NUREG/CR-4735
Volume 3

EVALUATION AND COMPILATION OF DOE
WASTE PACKAGE TEST DATA

BIANNUAL REPORT
Covering the Period February 1987 to July 1987

Figure 3. Normalized Si Release [Chick 1984] predicted by cubic model from 101 data points (TOP) and quadratic model from 76 data points (BOTTOM).

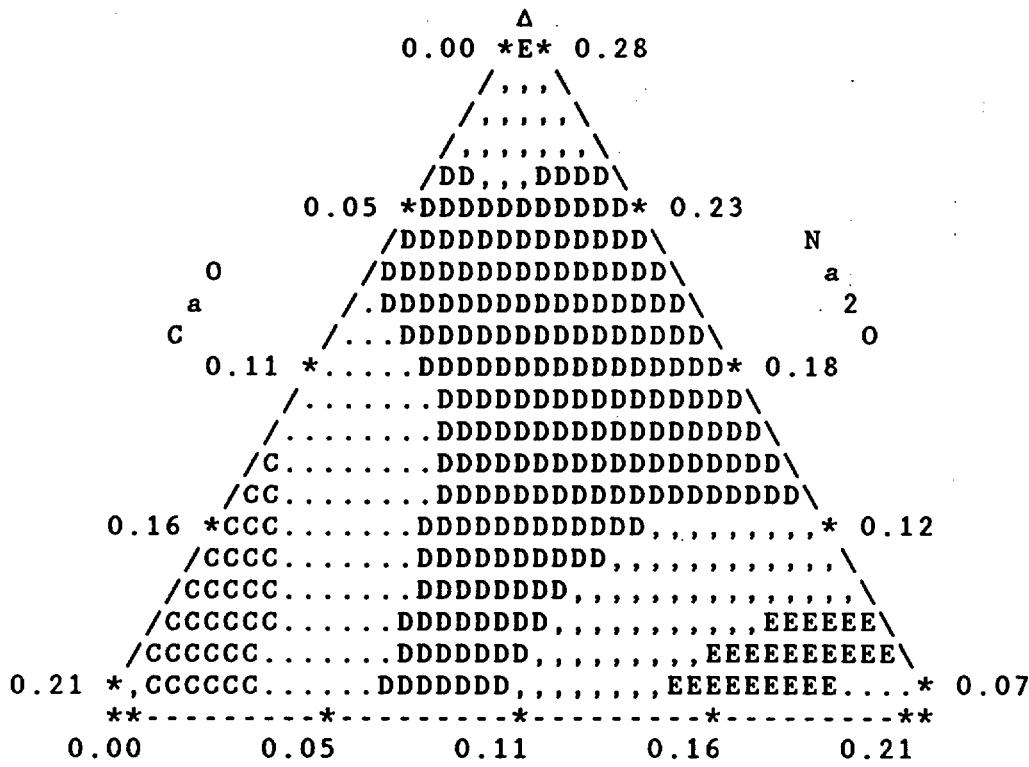
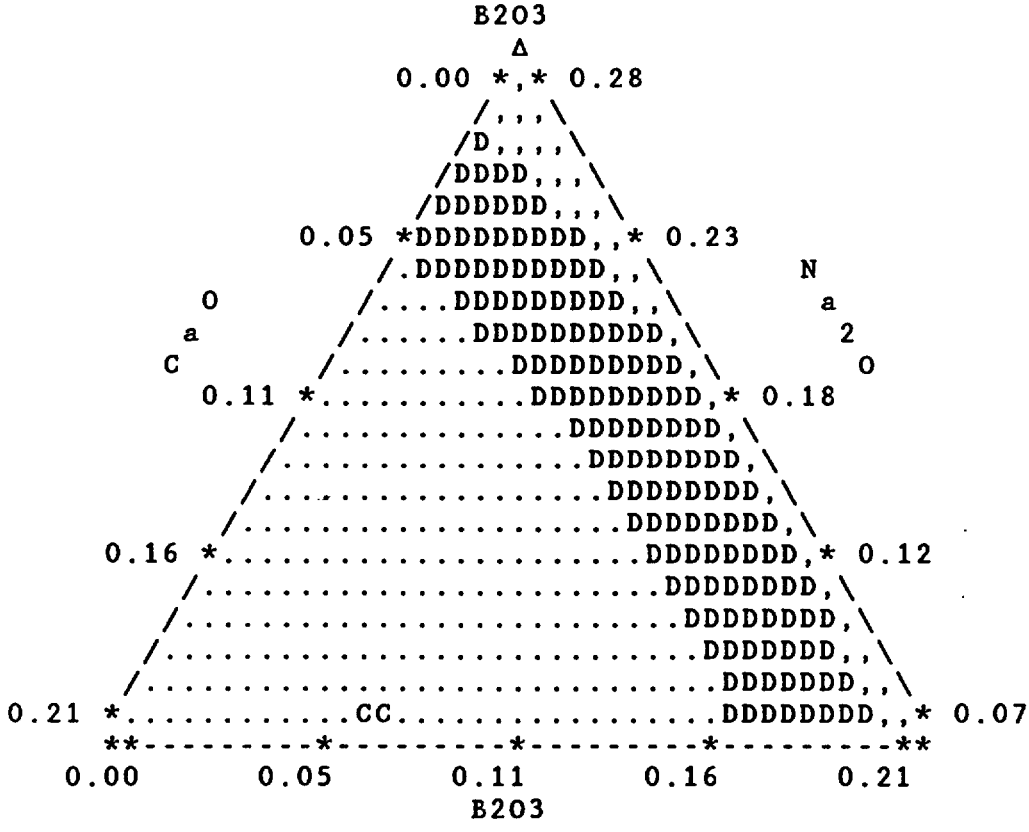
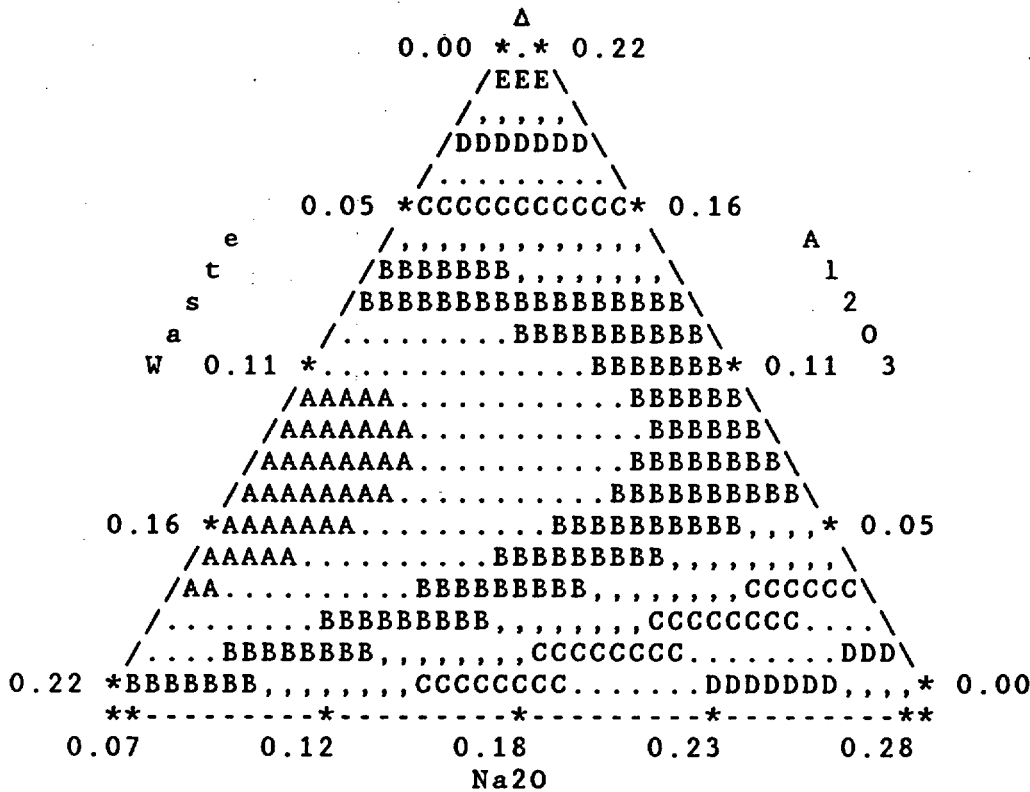
The two contour plots in Figure 2 contrast the original cubic model shown on the top with the alternative quadratic model shown on the bottom. The two plots are generally similar. However, the quadratic model does not show a distinct minimum in the middle as the cubic model does. Rather, the quadratic model suggests that better leach performance can be obtained

Figure 3 also contrasts the cubic and quadratic models but in terms of a different perspective on the response surface. The study by Chick, et al. discusses the fact that better leach performance can be obtained with more CaO and less B_2O_3 than has been recommended in previous studies [Chick 1984]. While this conclusion seems generally to hold for both models, the change in leach behavior is more gradual under the quadratic model. Moreover, the quadratic model shows a minimum at the lowest level of Na_2O for B_2O_3 near 0.06.

Figure 4. Normalized Waste Release [Chick 1984] predicted by quadratic model from 76 data points.

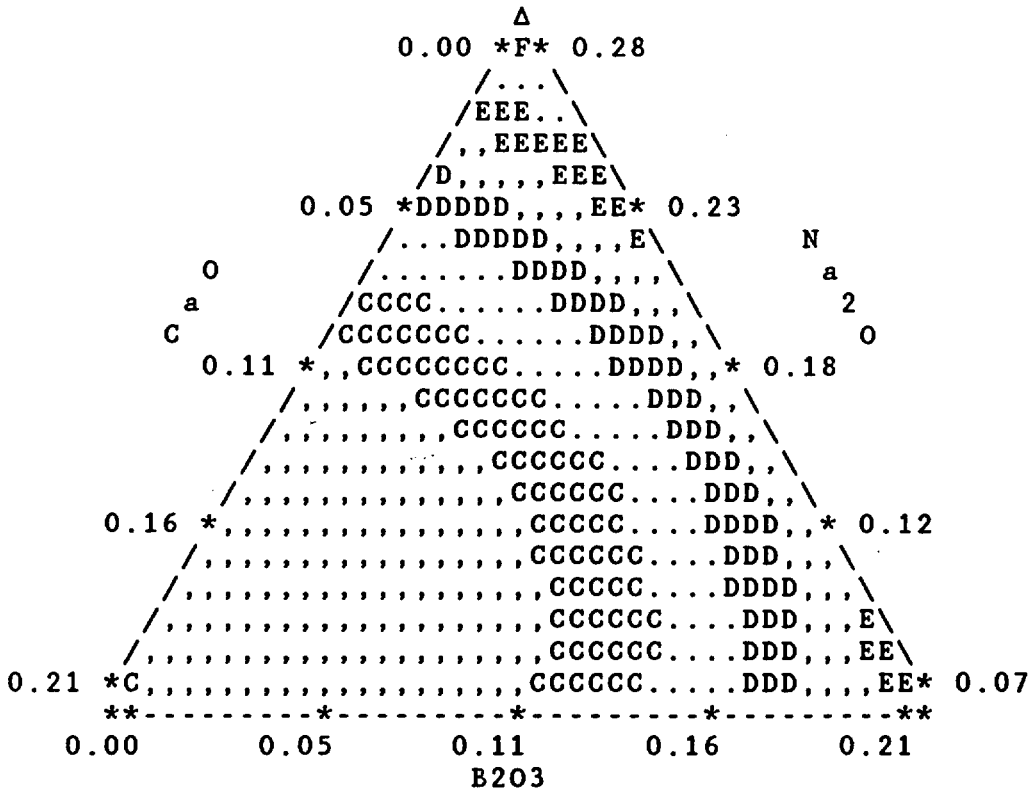
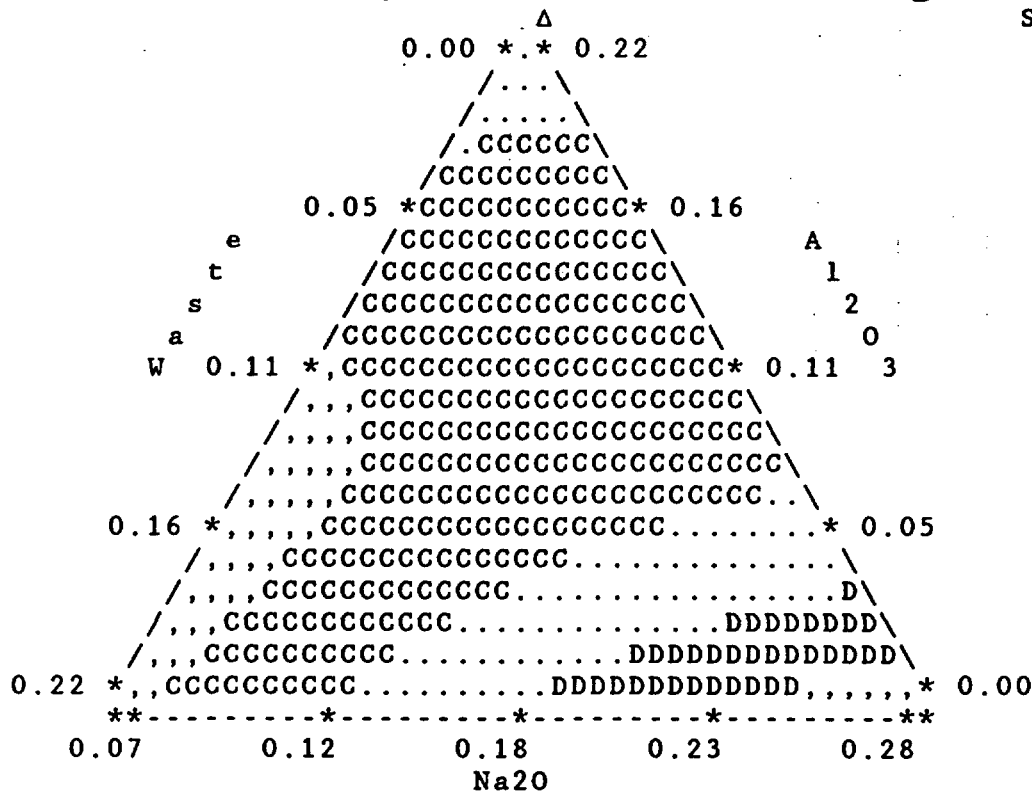
Figure 4 shows the quadratic model obtained for another leach component, the logarithm of the normalized Waste from the 28-day MCC-1 test. The top plot shows the components that are shown in Figure 2, and the bottom plot shows the components that are shown Figure 3. The top plot shows distinctly that better leach performance can be obtained by substituting Al_2O_3 for Na_2O while holding the Waste constant. The bottom plot supports the assertion in the original study that better performance is obtained with higher CaO and correspondingly lower B_2O_3 .

Figure 5. Composite Leach Response [Chick 1984] predicted by quadratic model from 76 data points.

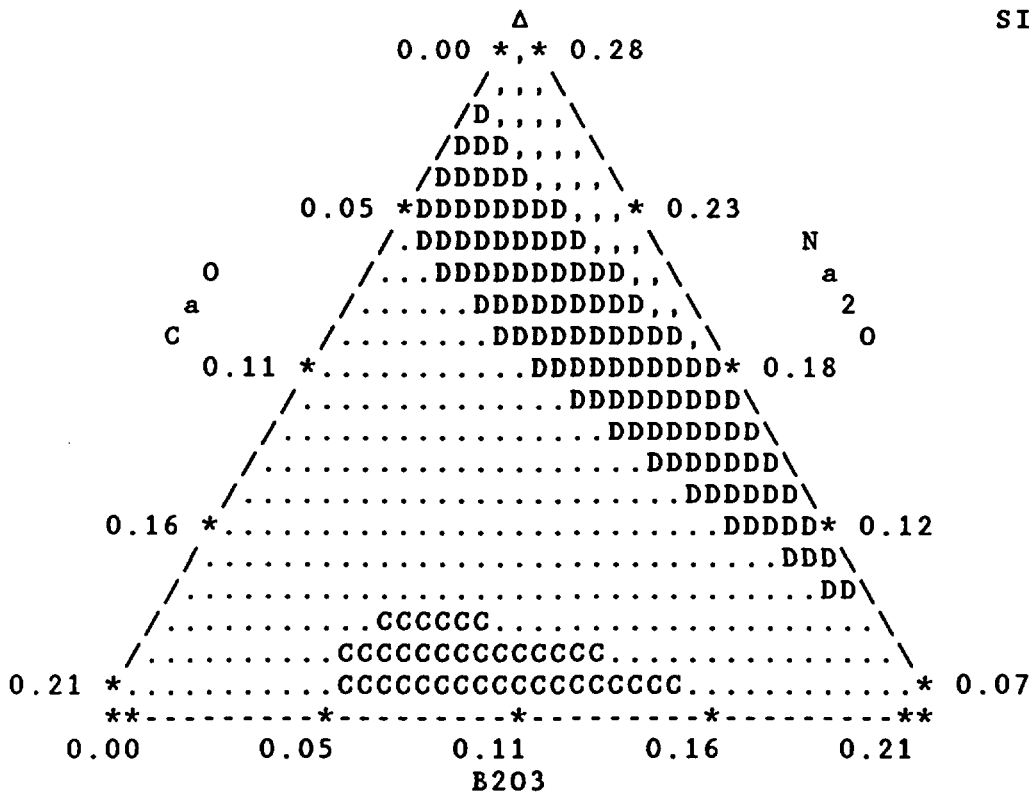
Figure 5 shows the quadratic model obtained from the composite leach response used in the original study to judge leach performance. This composite response is calculated from responses from five of the seven leaching tests performed. Again the top plot corresponds to Figure 2, and the bottom to Figure 3. The top plot shows better leach performance is obtained with more Al_2O_3 and less Na_2O . The bottom plot suggests that for low levels of Na_2O , the substitution of CaO for B_2O_3 can be carried too far.
